Public Works Department – Engineering Division

ADDENDUM NO. 3

PROJECT 5067 WTP FILTER IMPROVEMENTS AND HYPOCHLORITE CONVERSION

DWG. NO.
C120

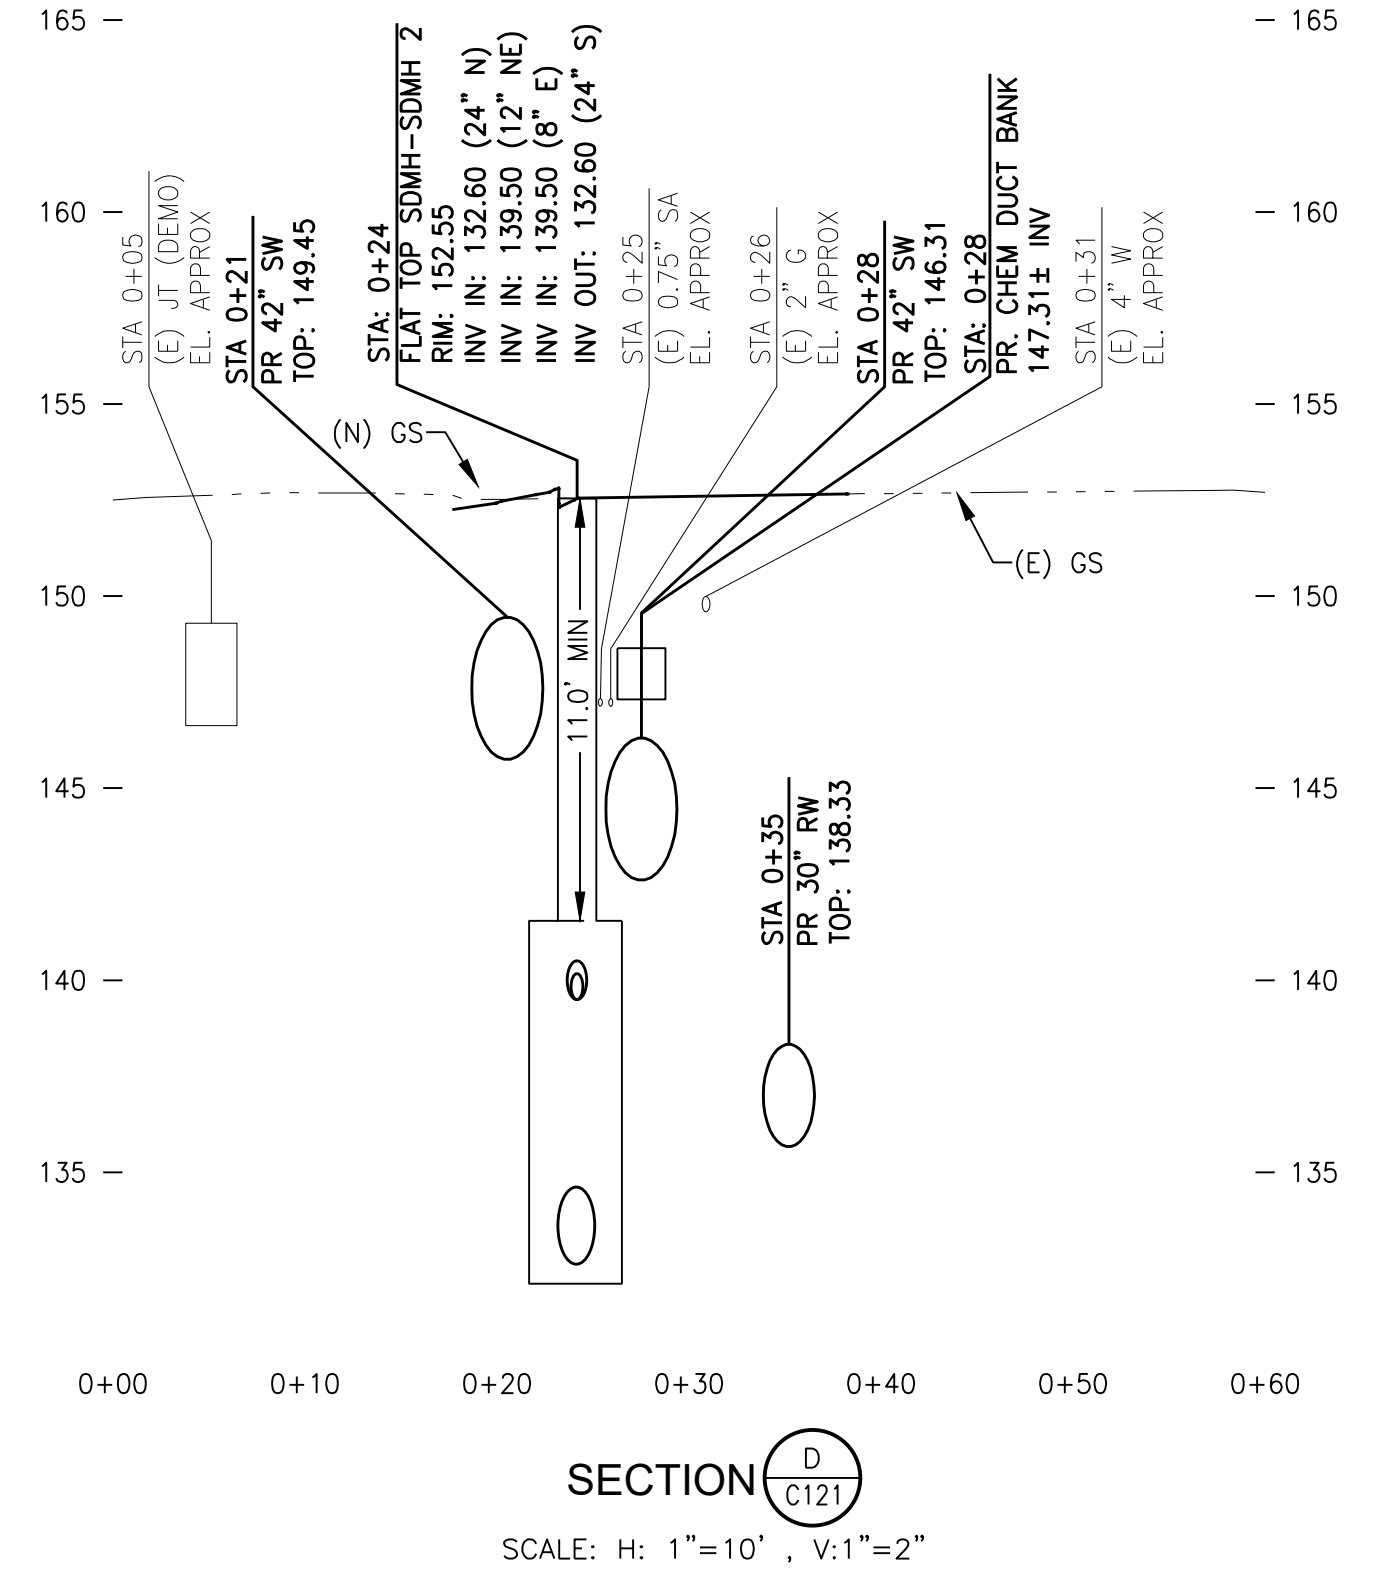
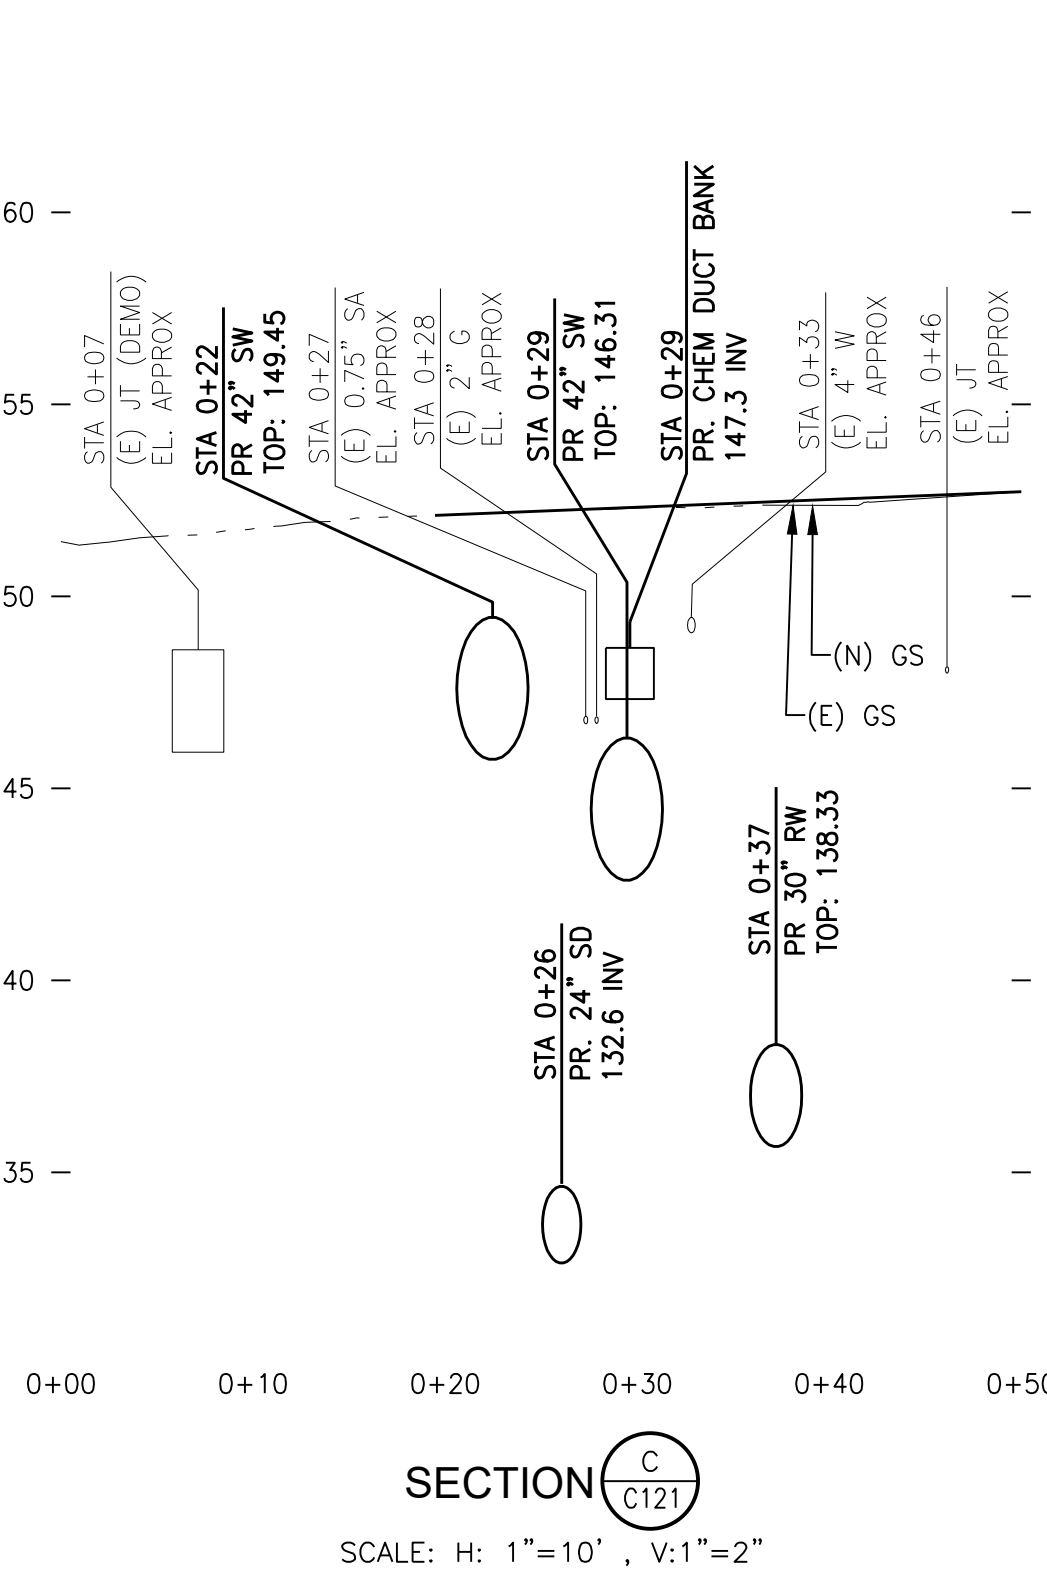
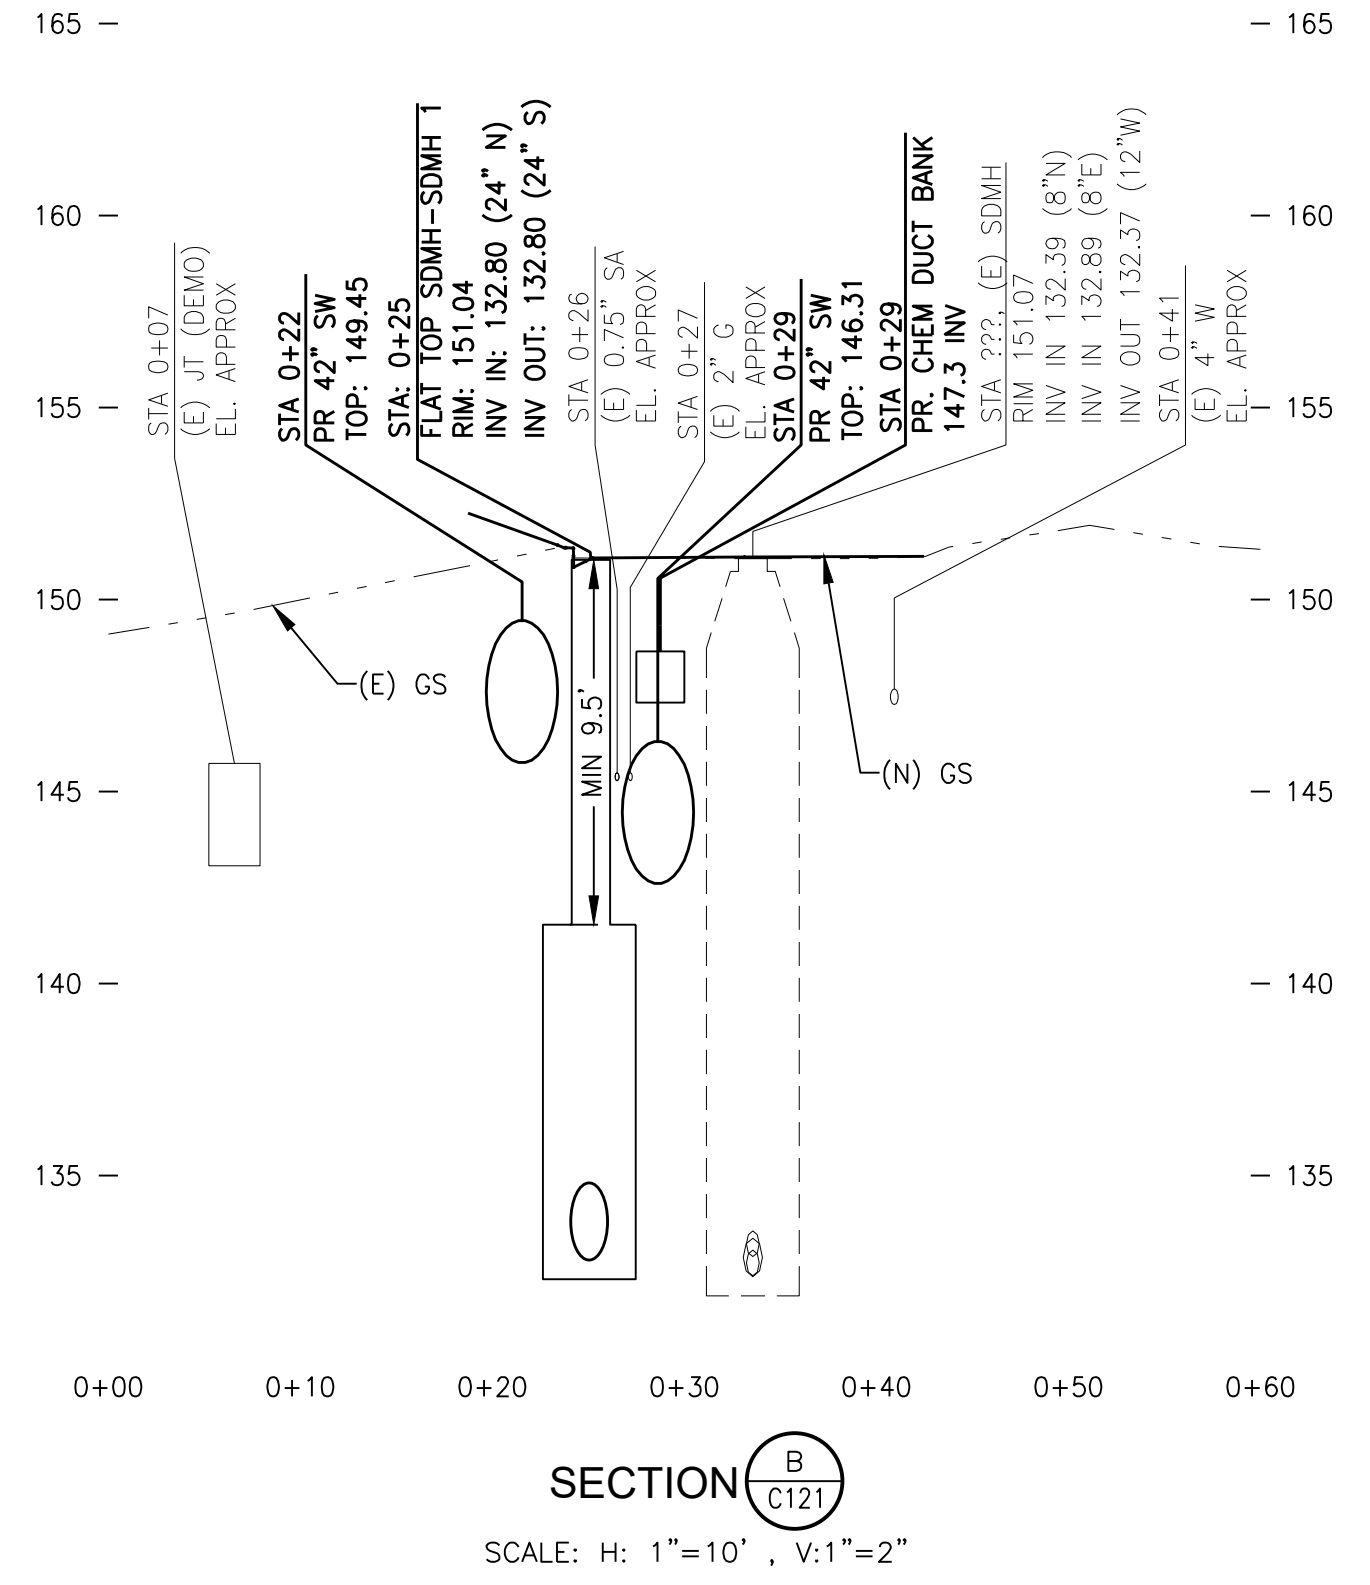
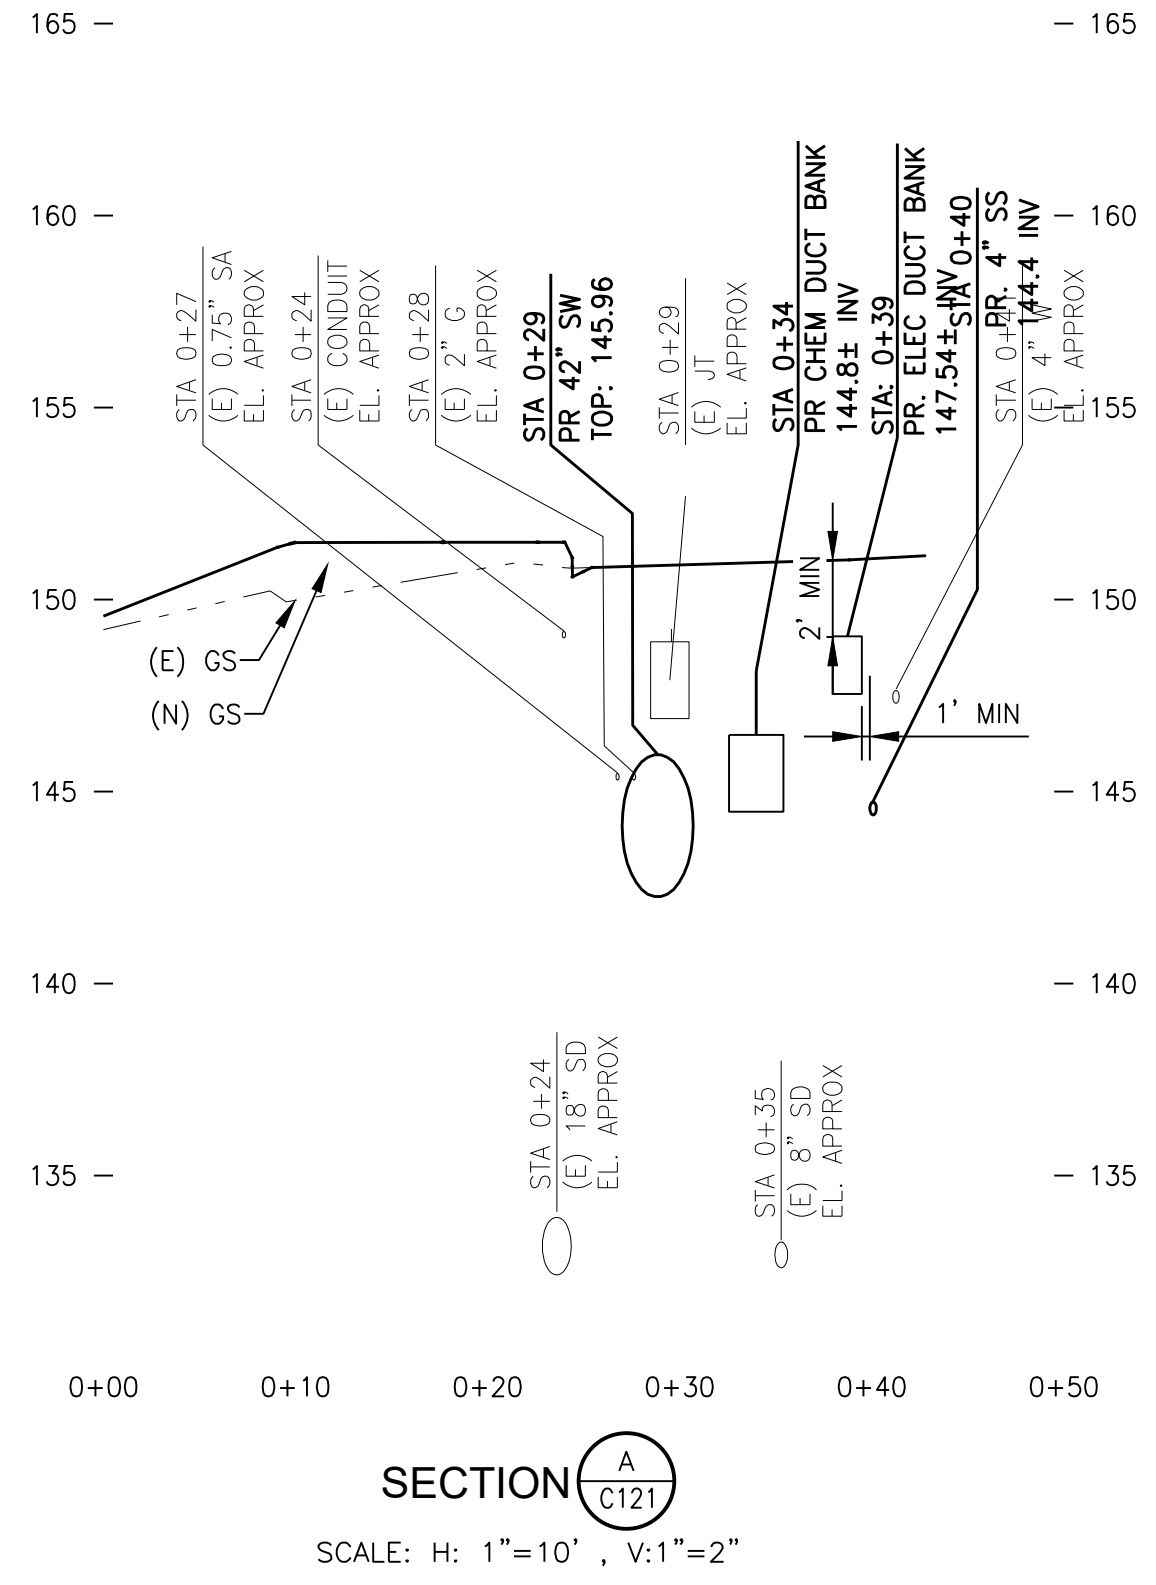
46. Replace Drawing C120 with the attached revised Drawing C120.

37. Drawing C104 calls out Pipe Connection #2 as 36" CFE tying into the existing 30" CFE line and references Detail 2 on Sheet C120. Detail 2 on Sheet C120 shows the existing CFE line as 36" pipe. Please confirm the correct size of the existing CFE line.
